TRANSMITTAL

Subject: **Notice of Intent Revised Plans**
Proposed Access Staircase & Mitigation
Plantings
David and Deborah Salant
41 & 83 Alfred Metcalf Drive
S. Dennis, MA
Map 183 Parcels 86 & 88
DEP File No: SE 16-2650

Summary of Revised Documents

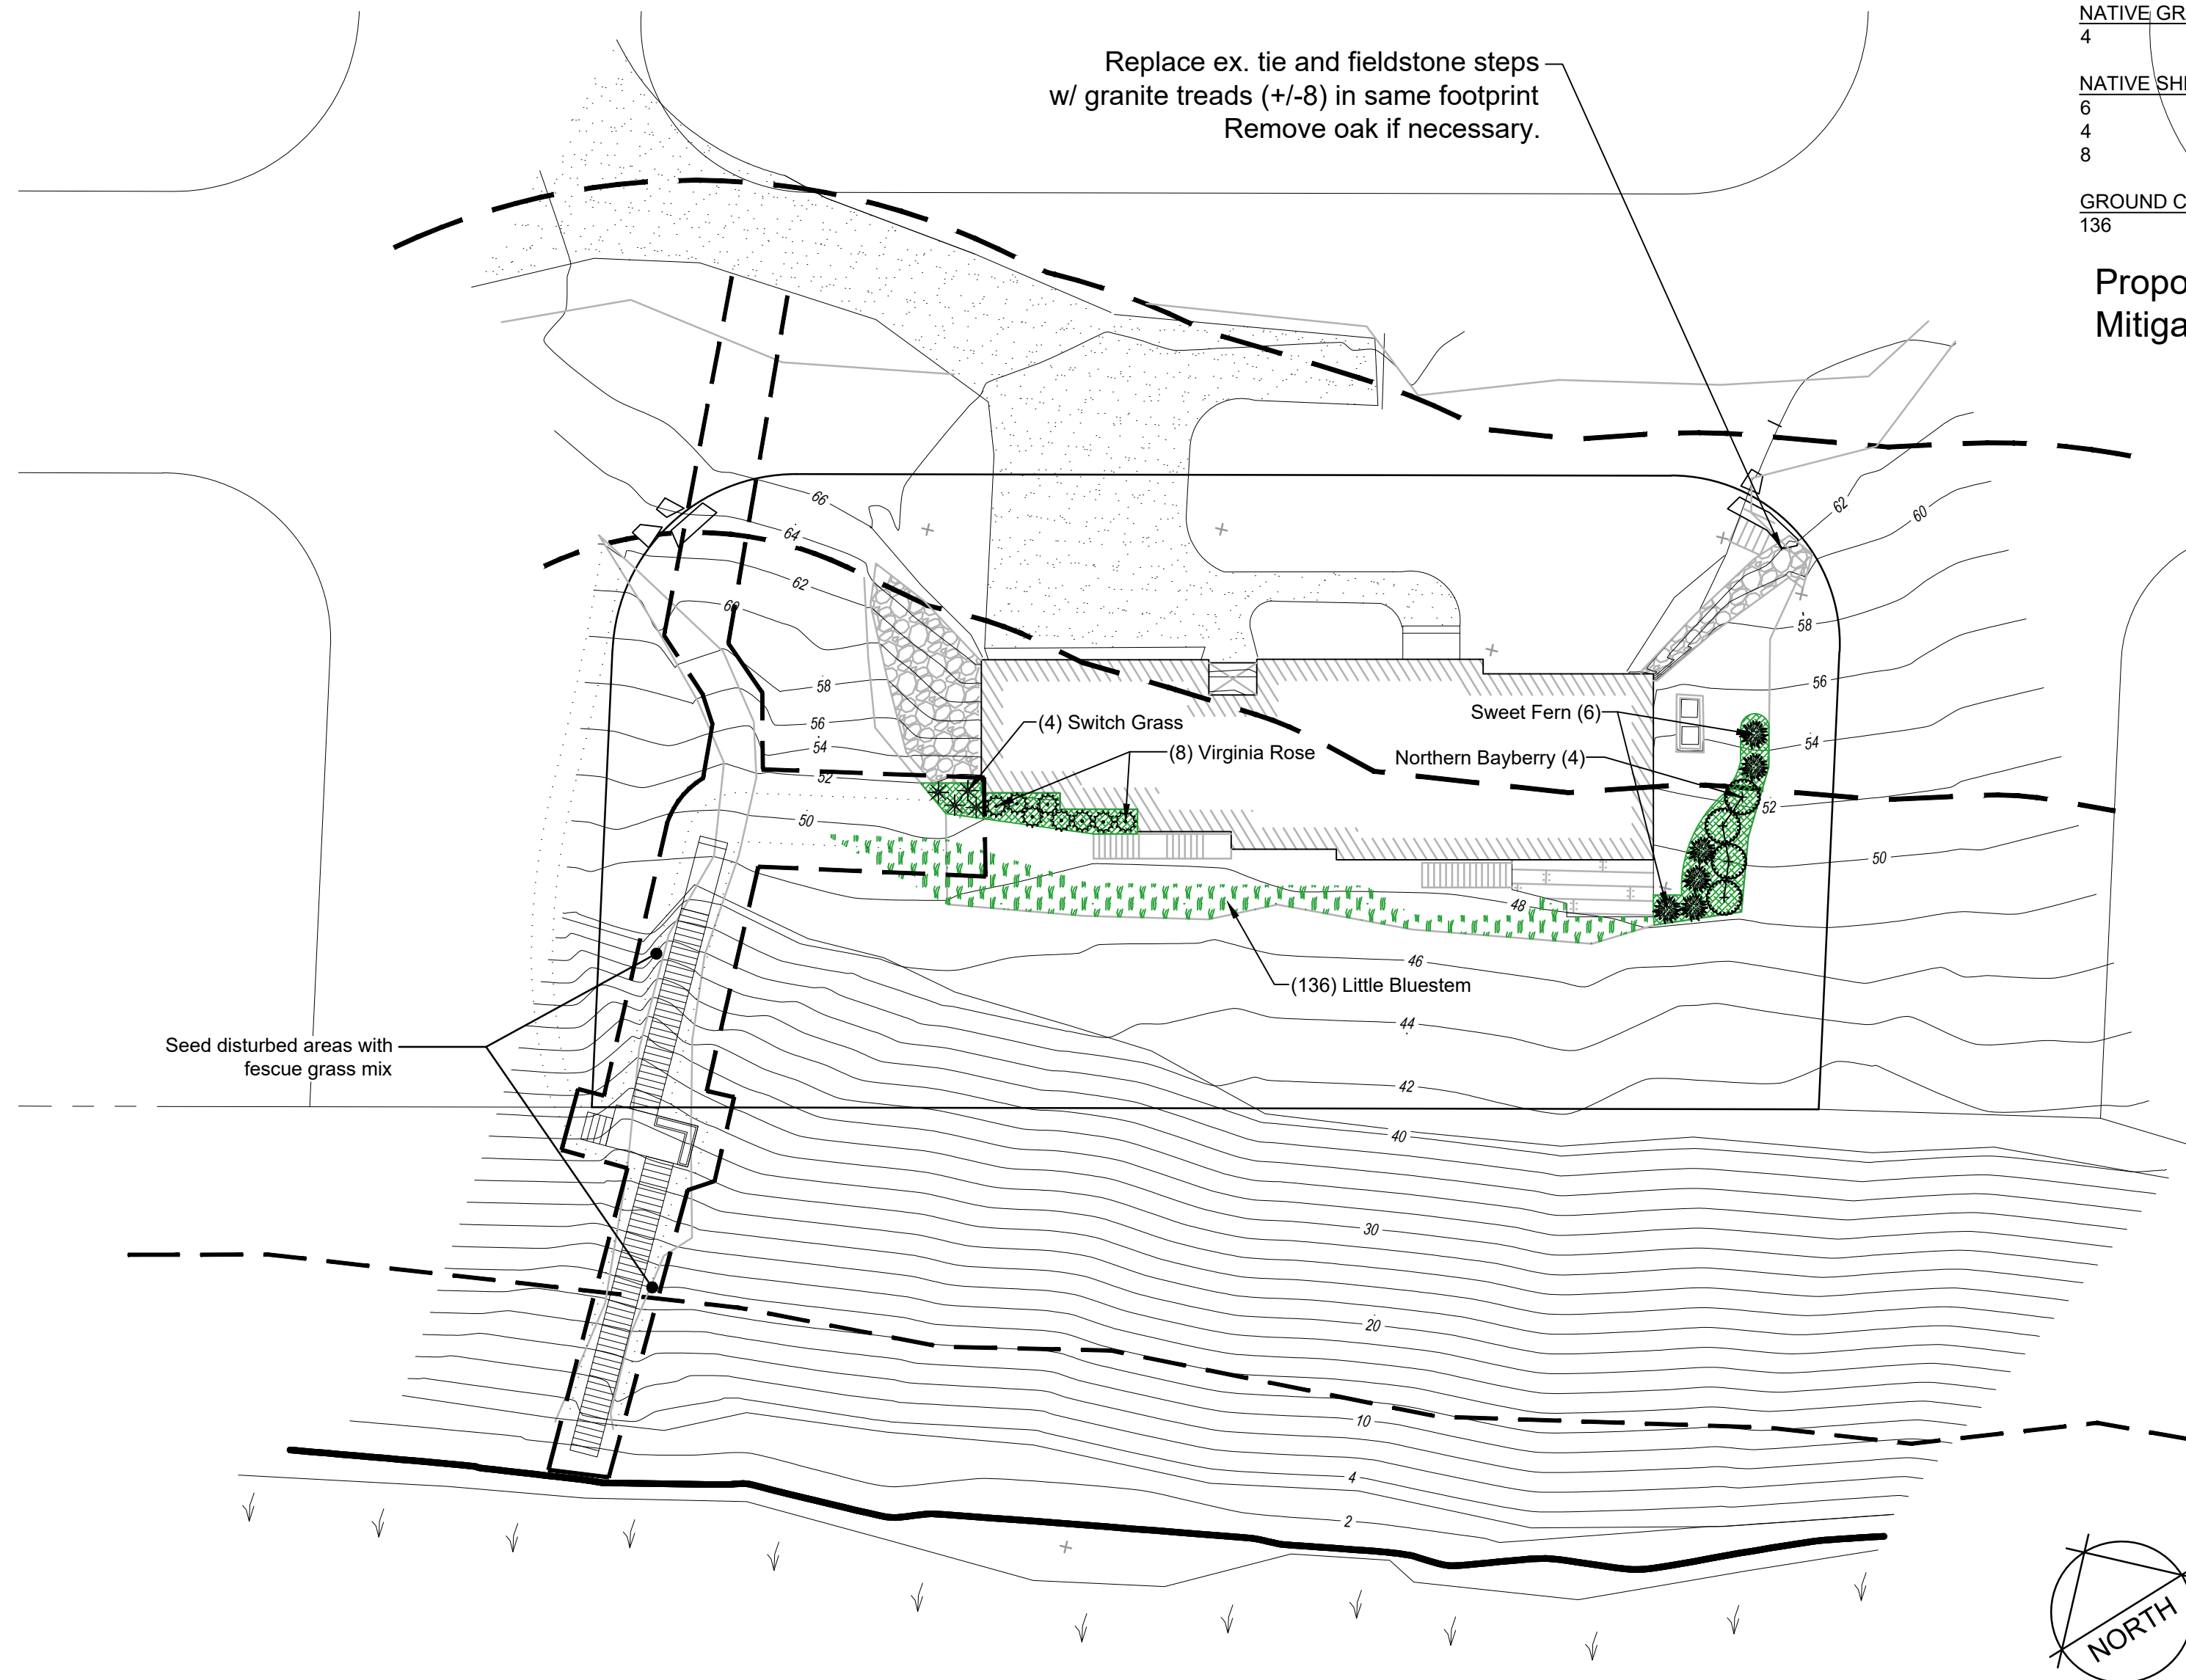
Taking the Commissions comments into consideration, the project plans C-100 and C-300 prepared by Coastal Engineering Company, Inc. (CEC) were revised. The revised plans dated 09/01/2022 show a slightly rotated proposed stair location which avoids the existing oak tree at the bottom of the coastal bank. There is one oak tree about halfway down the Coastal Bank that is proposed to be removed. This tree has become severely undermined exposing much of the tree's root system. The tree could cause damage to the coastal bank and the proposed stairs if it were to fall after the stairs are built. Photos of the undermined oak tree were submitted to the Commission on 08/10/2022.

The project plans also show an alternate proposed footpath through Susan Eldrege Way to access the intermediate platform of the proposed stairs. The proposed stairs are intended to be used by the Salants and the property owners in the neighborhood with deeded rights to 83 Alfred Metcalf Drive. The primary access for the other property owners in the neighborhood is through the existing footpath on 41 Alfred Metcalf Drive that leads to the top of the proposed stairs. The Salants are allowing the other homeowners to access the stairs through their property. However, to account for any change in ownership of 41 Alfred Metcalf Drive, the Trustee of the Follins Pond Realty Trust and the Salants are proposing an additional alternative footpath through Susan Eldrege Way to access the intermediate platform of the proposed stairs. This would allow the other homeowners in the neighborhood to continue to access the stairs and beach if access through 41 Alfred Metcalf Drive was ever negated.

If the alternate footpath was ever built and used, steps would be needed to access the intermediate platform from the footpath. These additional steps are shown on the project plans and increase the total coverage from 404 sf to 419 sf. The mitigation plan prepared by Philip L. Cheney was revised on 08/25/2022 to show the new proposed stair location and the updated mitigation area of 838 sf.

NO.	DATE	REVISION
2	09-01-2022	ADD ALTERNATE FOOTPATH, ADJUST PLATFORM LOCATION
1	08-09-2022	ROTATE STAIRS, ADD NOTE FOR OAK TO BE REMOVED
